I-81 Viaduct Project

Project Recommendations of the Syracuse Urbanism Club

I-81 Viaduct Project: Official Project Recommendations

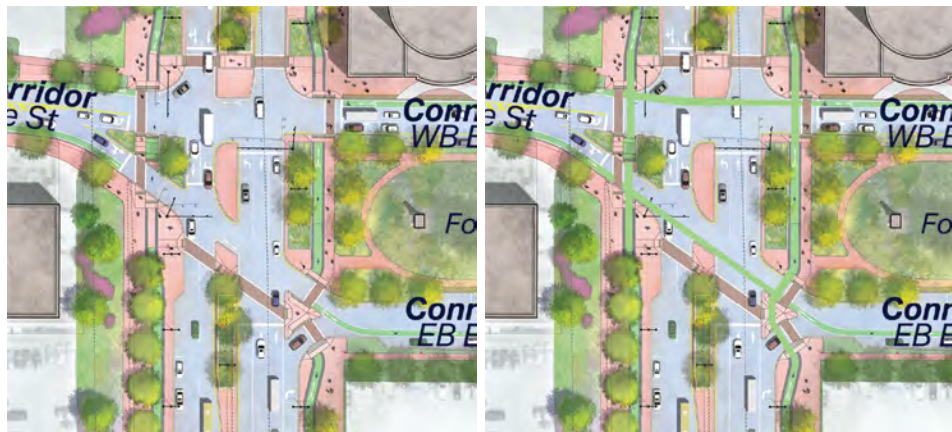
4. Bus Shelters.

Provide protected, accessible bus shelters with LED boards and clearly legible schedules at all bus stops within the I-81 Viaduct Project scope.

Left: NYSDOT Bike Lane Markings at Intersections

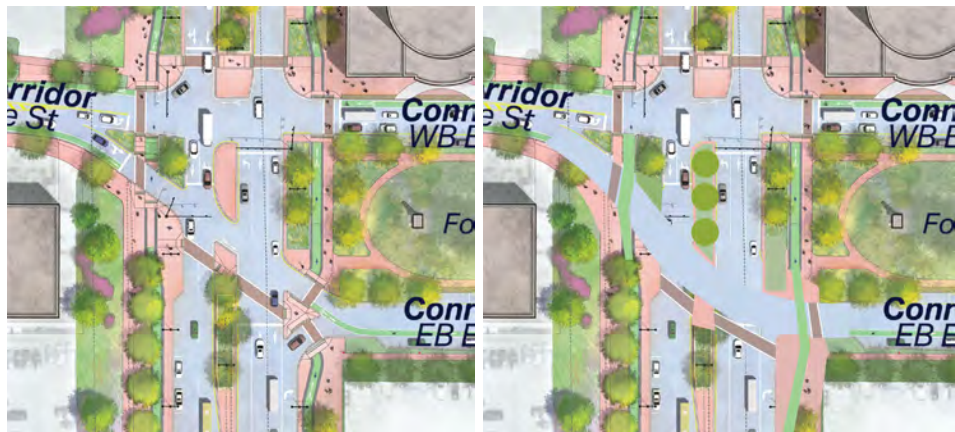
6. Mark Bike Lanes at Intersections.

The green surface marking the location of bike lanes should continue across intersections. See our revised drawing below. Apply this to all intersections.

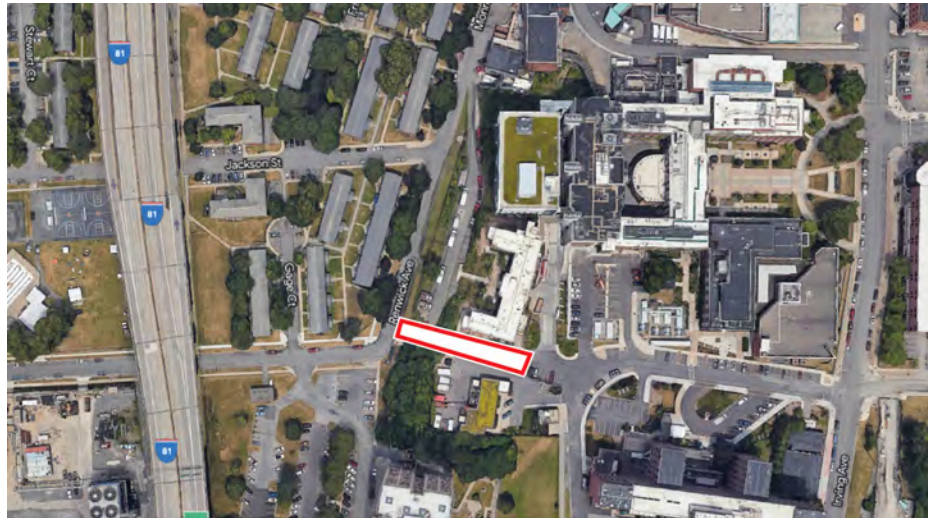
At East Adams and Almond, the transition between Almond Street's shared use path and the northbound bike lane is more clearly marked.

Left: NYSDOT I-81 Colvin Street Ramp Area

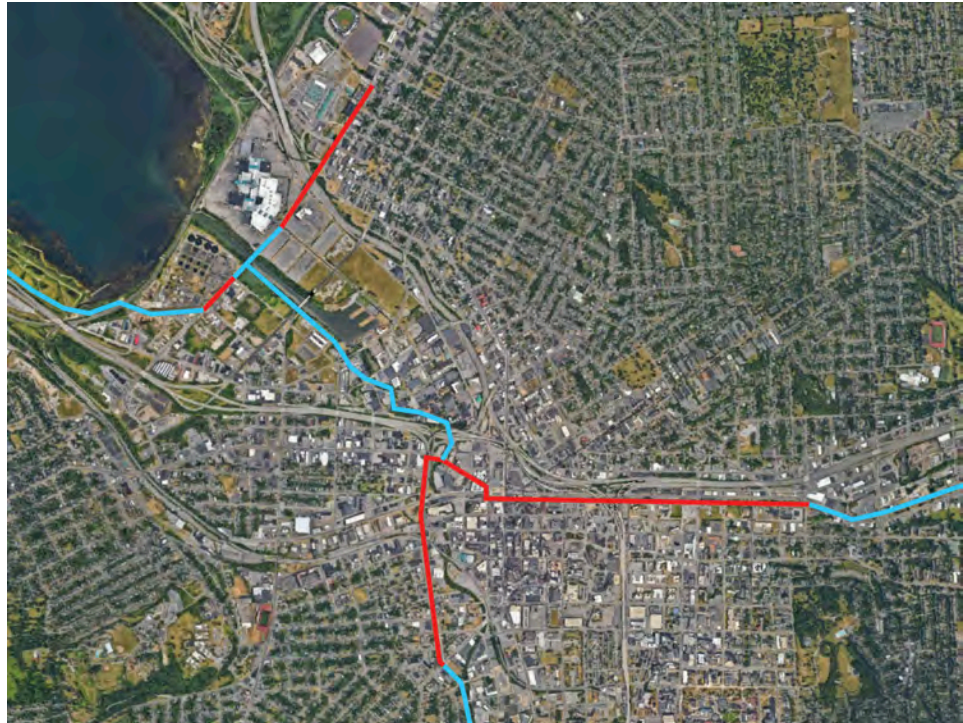
11. Colvin & Dougal Crosswalk

Add a crosswalk at E Colvin Street and Dougal Avenue.

13. Bollards at Clinton Square.

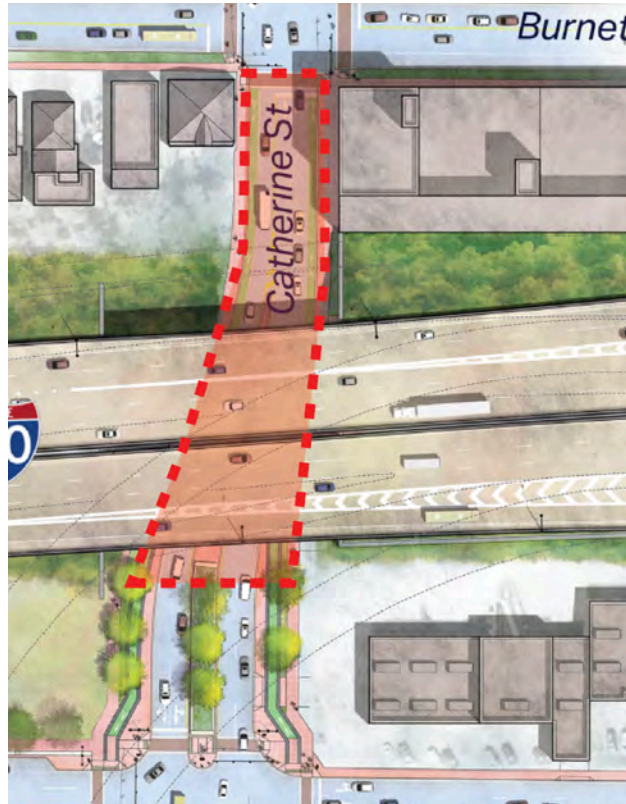
Replace the gates with bollards at the southern corners of Clinton Square, which currently block bike access for the Empire State Trail along Water Street.

Left: NYSDOT Design for Erie Blvd and West St Interchange
 Right: Syracuse Urbanism Club's Flattened Intersection Design

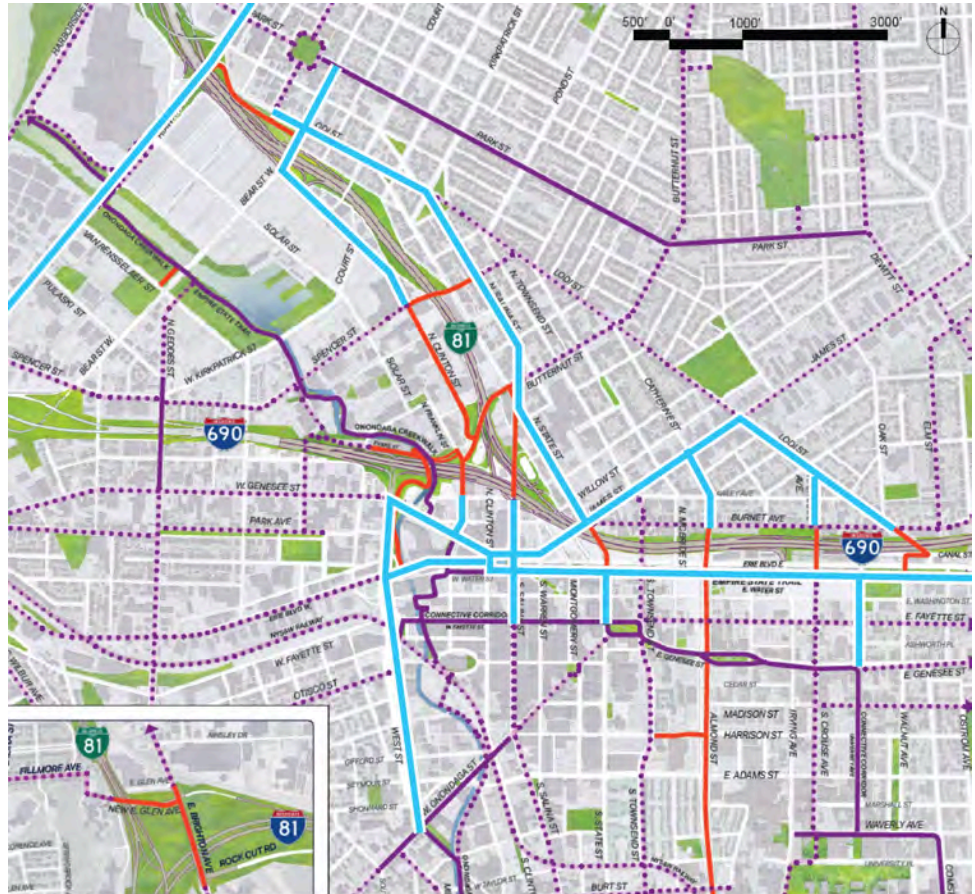
17. Bring Erie & West Intersection to Grade

Bring the intersection of Erie Blvd West and West St to grade. The current design makes for a poor pedestrian experience and disconnects Downtown from the Park Avenue Neighborhood.

KEY

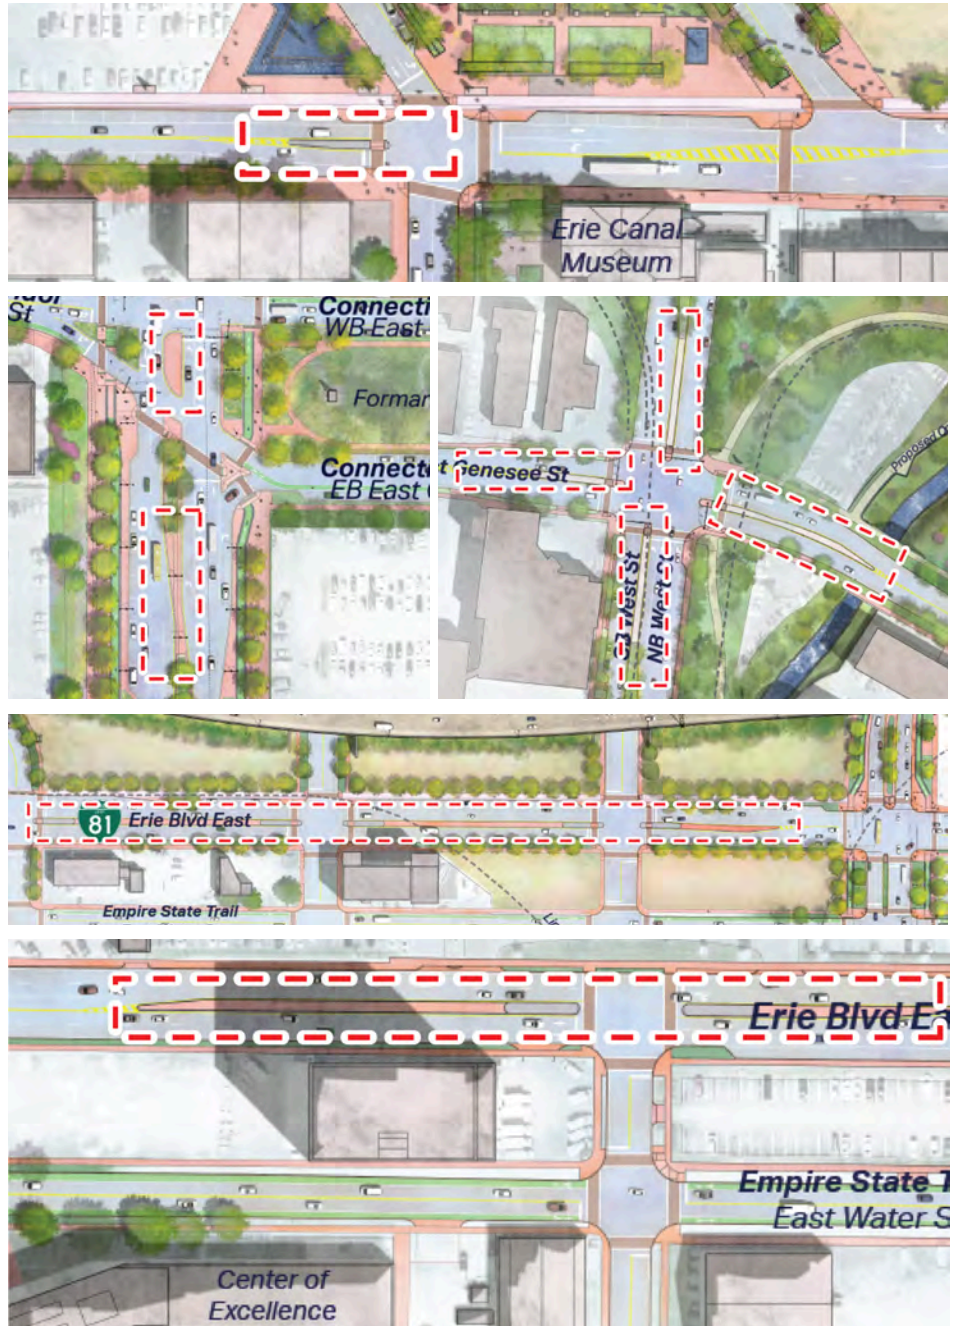
18. Connect New Bicycle Network.

Connect existing and new NYSDOT-proposed bike lanes into a continuous network. Below, orange lines are bike lanes proposed by the NYSDOT. The Syracuse Urbanism Club proposes connecting these with additional protected bike lanes shown in blue below.
